**LIMERICK CITY AND COUNTY COUNCIL REPORT TO AN COIMISIÚN
PLEANÁLA IN RELATION TO PRESCRIBED BODIES SUBMISSIONS
RECEIVED IN RELATION TO BALLINLEE WINDFARM IN ACCORDANCE
WITH REQUIREMENTS OF SECTION 37 OF THE PLANNING AND
DEVELOPMENT ACT 2000 (AS AMENDED)**

ACP REFERENCE: ACP-323780-25

Planning Ref: 25 323780 (SID) Ballinlee Windfarm - Further submissions (OPW Heritage)

Figure 2 - Proximity of Lough Gur to Ballinlee Wind Farm (orange denote turbines) and Garrane Wind Farm

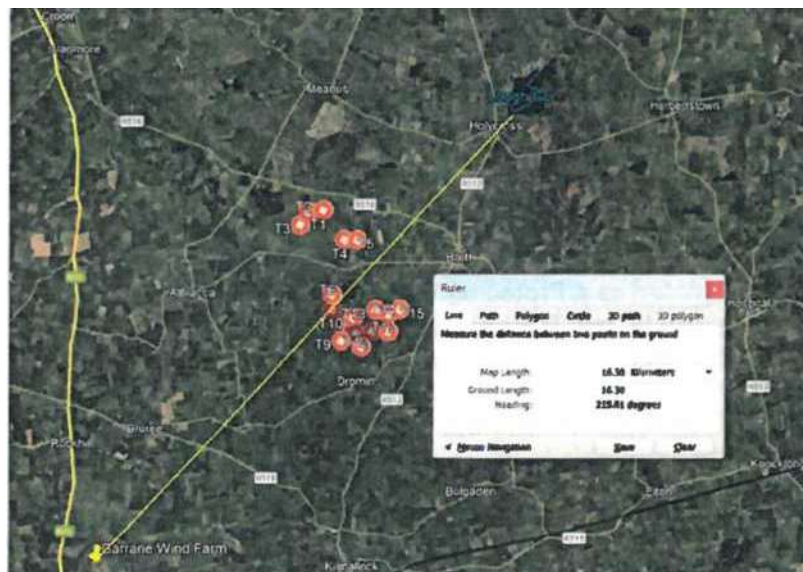
The same applicant has provided a more honest photomontage within their separate application for the Garrane Wind Farm within *the Landscape and Visual Impact Assessment* with VP21 so are clearly more familiar with Lough Gur and the available vantage points than the information presented in this application. It is noteworthy that the proposed Ballinlee Wind farm is c. 5.5km from the shores of Lough Gur and the Garrane Wind Farm is c.16km from the shores of Lough Gur. The proposed Ballinlee Wind farm would be clearly visible and far more obtrusive from the location of VP21 of the Garrane Wind Farm application, yet this vantage point was not included in this application. This point is further demonstrated in Figure 2 below.

Figure 5 - Lough Gur Public Viewing Point (all turbines at ~160m high will be visible)

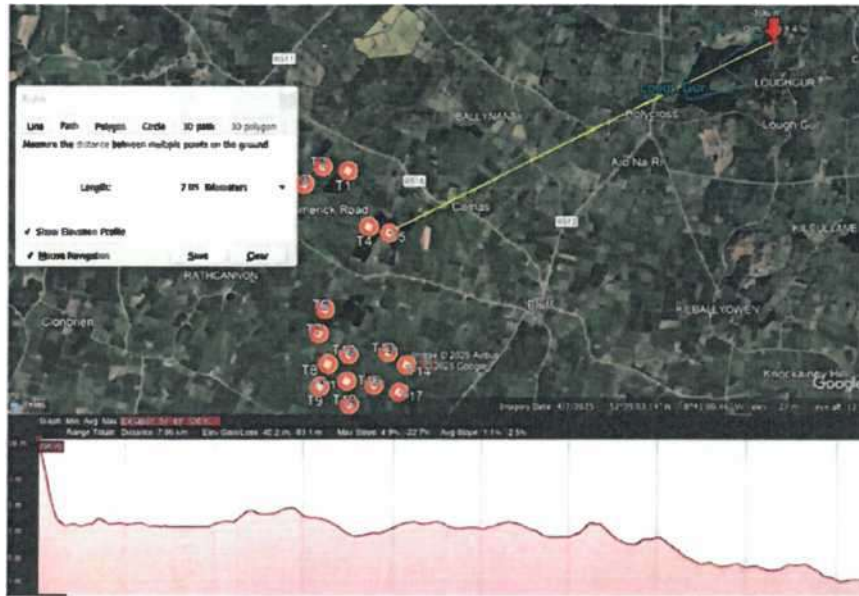
To provide further evidence of the visual impact of the proposed development on the Protected Views around Lough Gur Figures 5, 6, 7 & 8 demonstrate that the proposed Ballinlee Wind Farm will be clearly visible from the various vantage points identified. The applicant has neglected to provide photomontages from representative locations within the Protected View for the public and planning authority to be afforded the opportunity to understand the implications. It could be inferred that the EIA has not correctly considered the visual impact of the proposal in its assessment if it is based on the photomontages submitted with this application.
